MINOLTA α - 5	(2163-090)
MINOLTA α - 5 BLACK	(2163-091)
MINOLTA DYNAX 5	(2163-196)
MINOLTA DYNAX 5 DATE	(2163-296)
MINOLTA MAXXUM 5	(2163-395)
MINOLTA MAXXUM 5 DATE	(2163-495)
MINOLTA α -Sweet II BLACK	(2163-690)
MINOLTA α -Sweet II	(2163-695)

PARTS MODIFICATION LIST

2163-761

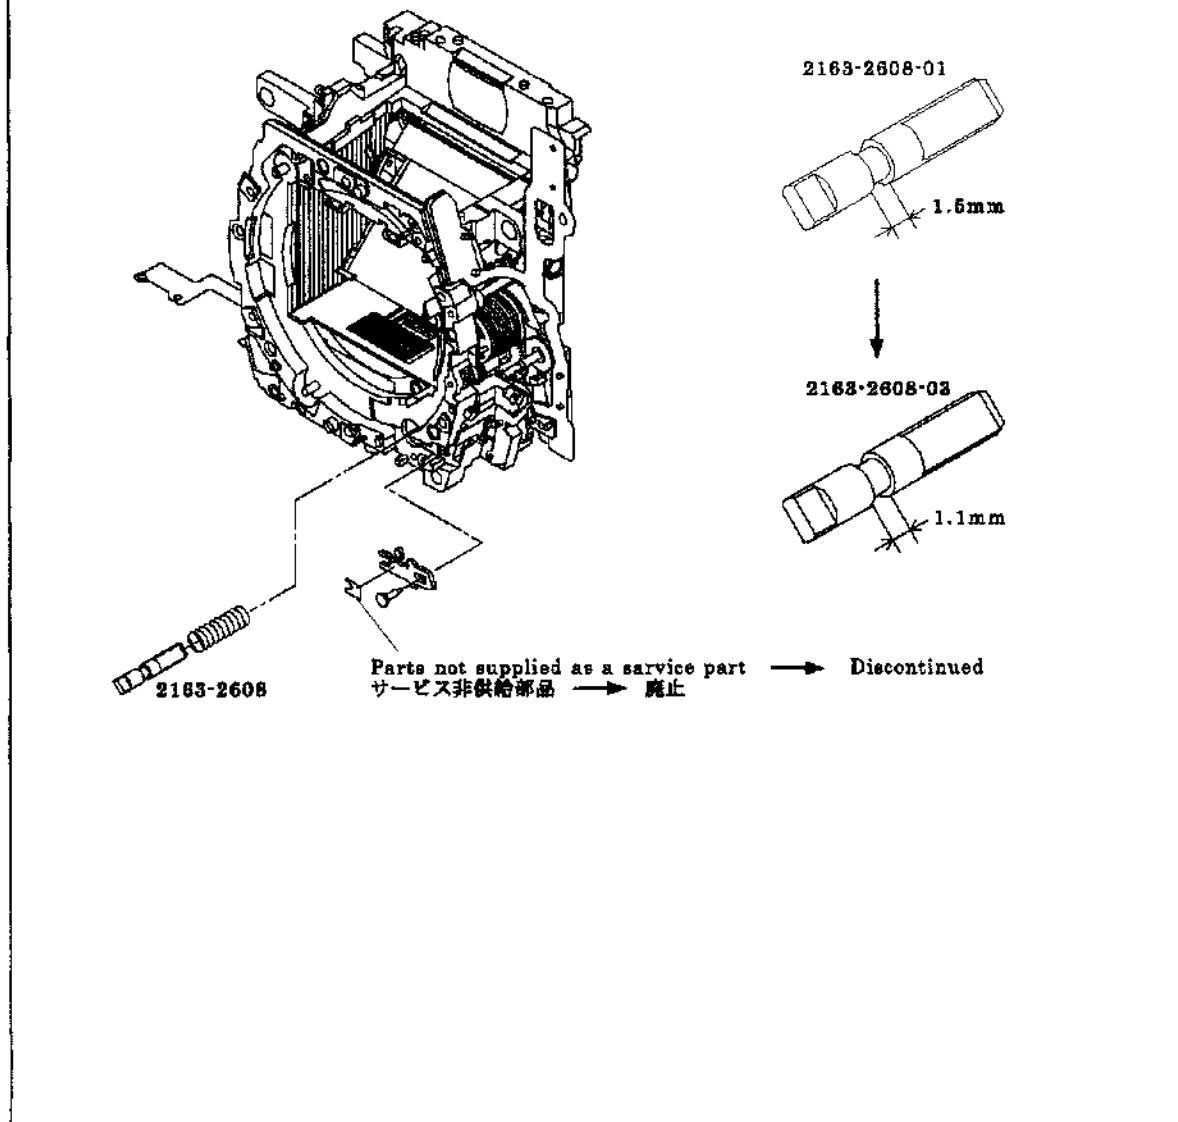
REASON 変更理由	AF切替え作動の改善 To improve AF SW			COMMON MODEL 共通機種	2163 Series
Previous	2163-2608-01	→×	×←	2163-2608-03	New
Previous	サービス非供給部品 Parts not supplied as a service part	→×	×←	—	New
